ADDENDUM NO.1

ELLENDALE E.M.S. BUILDING
CITY OF ELLENDALE
ELLENDALE, NORTH DAKOTA
EC23-00-083

Date Issued: December 20, 2024
Bid Opening Date: January 30, 2025
Bid Opening Time: 3:00 PM (CT)
Bid Opening Place: Office of City Auditor
Ellendale, North Dakota

OVERHEAD DOOR BOLLARD DETAILS

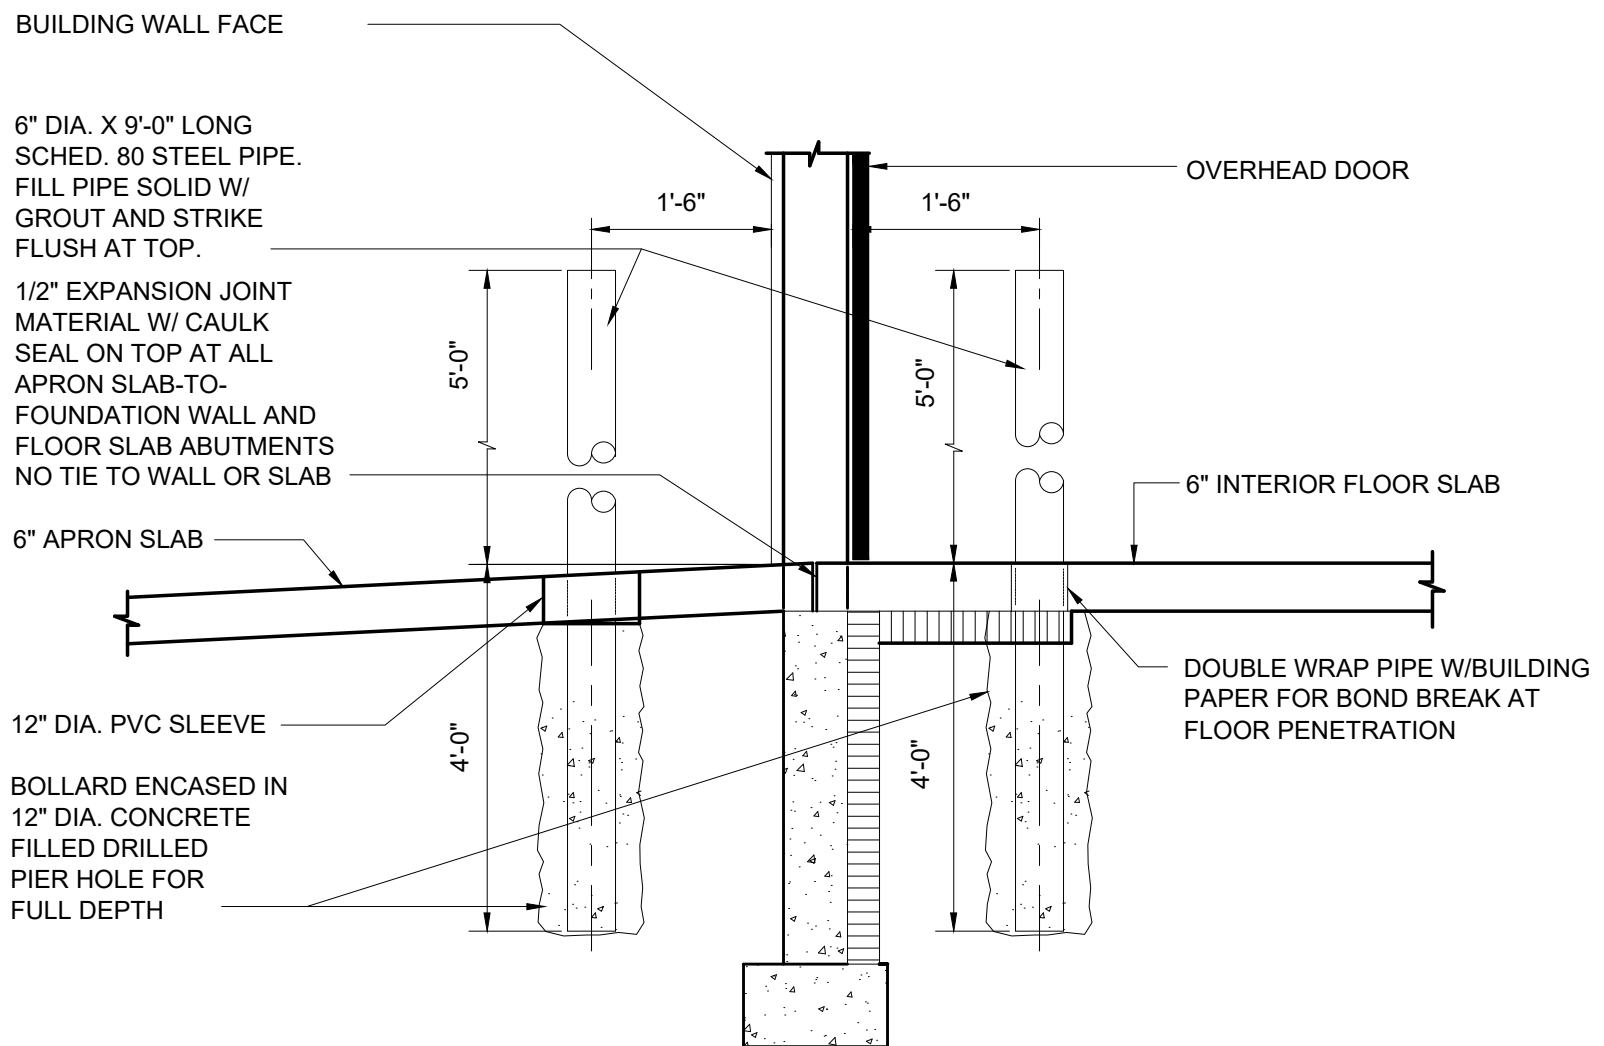
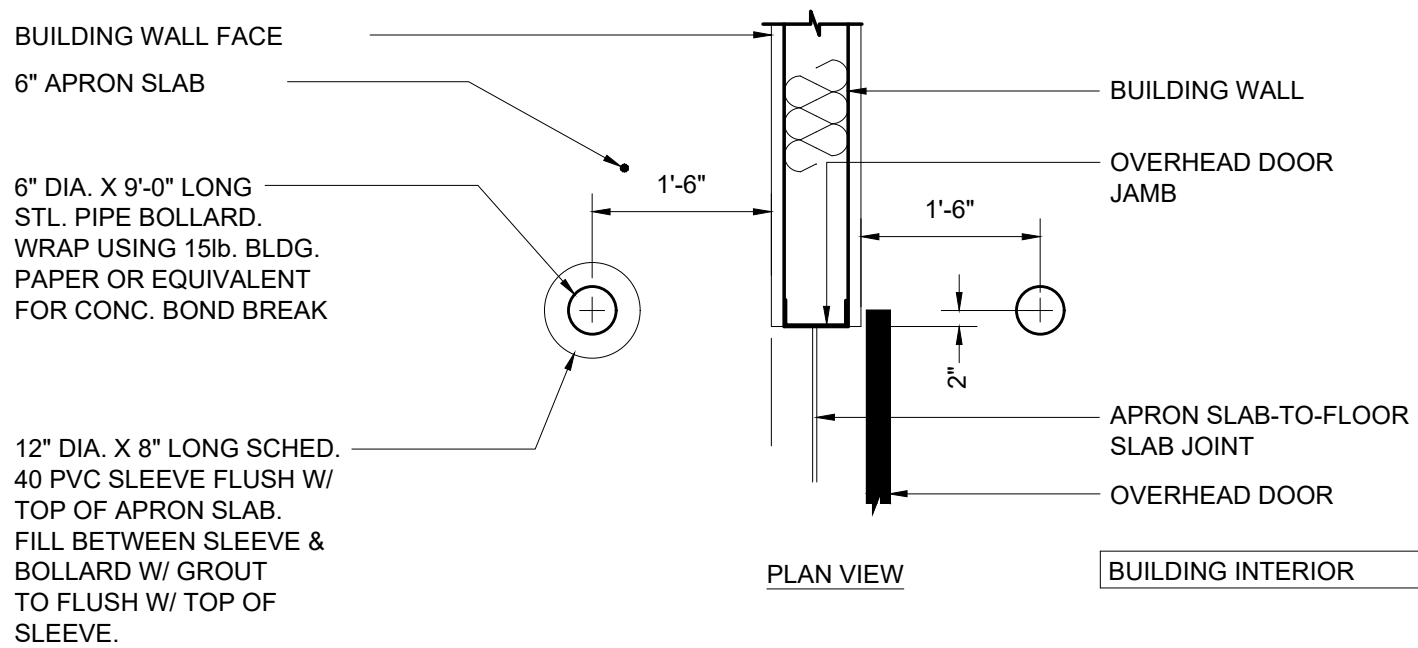
FLOOR PLAN KEYNOTES: 4. 6" X 4'-0" HIGH CONCRETE FILLED STEEL PIPE BOLLARDS – SEE CIVIL. MODIFY NOTE TO READ – 6" X 9'-0" SCH. 80 STEEL PIPE. SEE BOLLARD DETAIL ATTACHED TO THIS ADDENDUM.

DETAIL 11/A8.2 REFER TO BOLLARD DETAIL ATTACHED TO THIS ADDENDUM FOR BOLLARD SIZE. CHANGE DIMENSION OF 4" TO CENTER OF BOLLARD TO 3" TO CENTER OF BOLLARD.
